APPLICATION TO THE RESIDENTIAL DESIGN
AND COMPATIBILITY COMMISSION (RDCC)

GENERAL MODIFICATION WAIVER

STREET ADDRESS: 1312 Central Park Ct

From: Hendricks, Brent
Sent: Tuesday, November 22, 2011 3:24 PM
To: 'Jim Nance'
Cc: Greg Hammonds; Benavidez, Sylvia; McDonald, John
Subject: RE: 1304, 1308, 1312, 1316, 1320 Central Park
Follow Up Flag: Follow up
Flag Status: Yellow

1316 & 1312 CENTRAL PARK CT.
REV. 10/31/11 CHANGE TO LEGAL SHEET

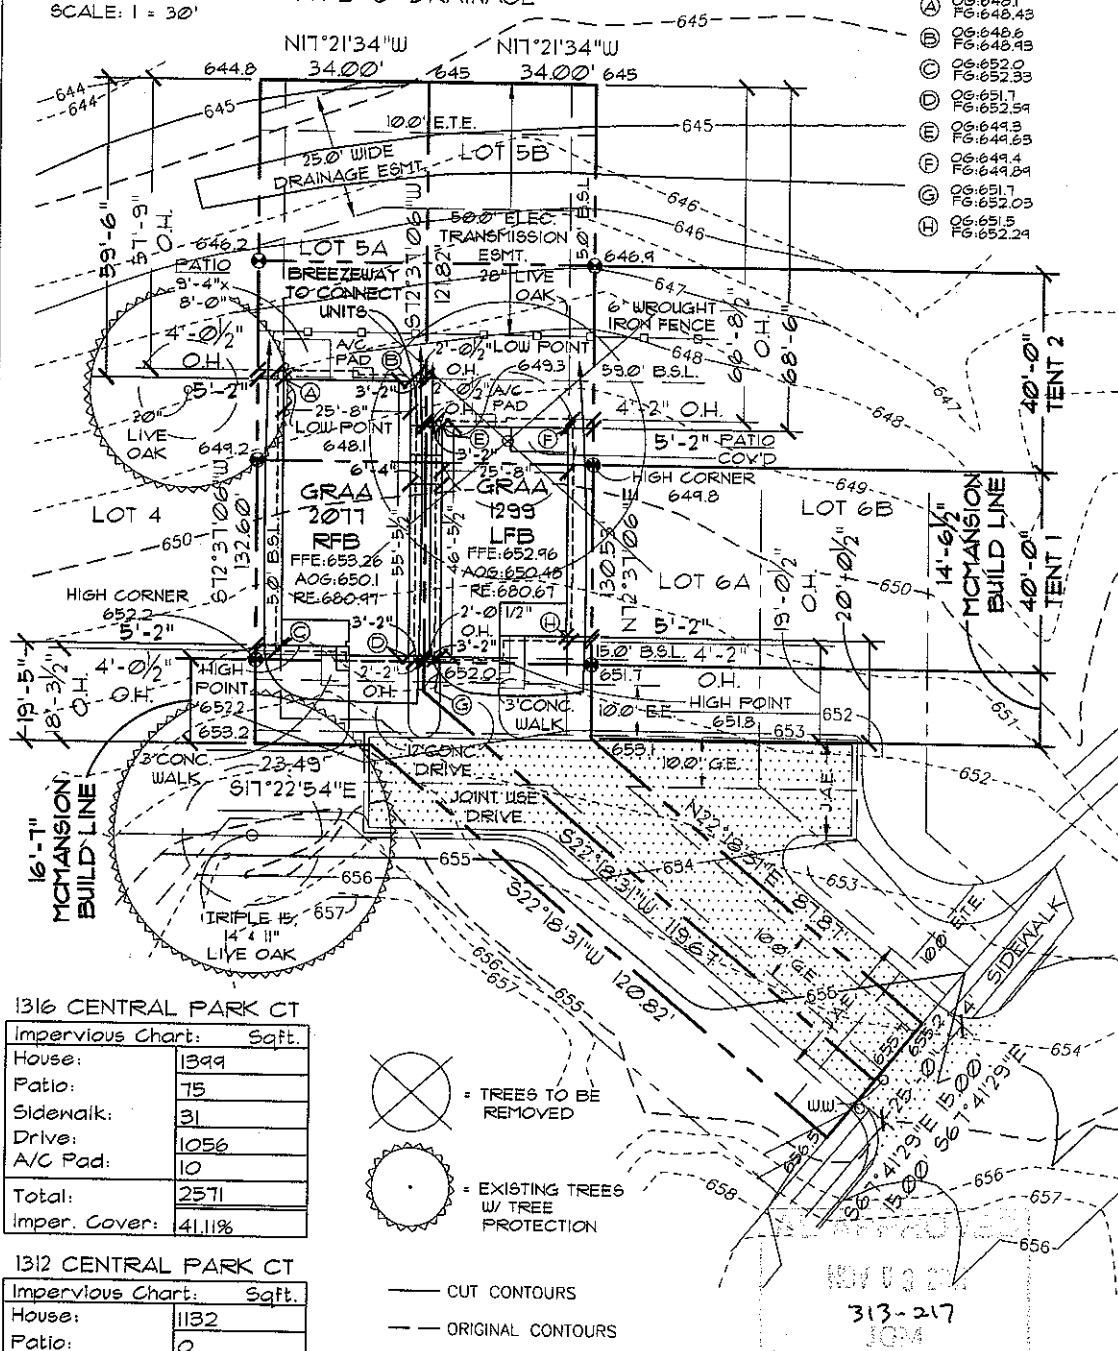
1312 Lot 5B - Variance from the Board of Adjustment for encroachment into the 25' Front Setback area.
Approval from RDCC,
Tree Review Required by City Arborist. Developer to set up appointment with City Arborist, supply arborist with a current site plan.

1312 Lot 5B - Variance from the Board of Adjustment for encroachment into the 25' Front Setback area.
Approval from RDCC,
Tree Review Required by City Arborist. Developer to set up appointment with City Arborist, supply arborist with a current site plan.
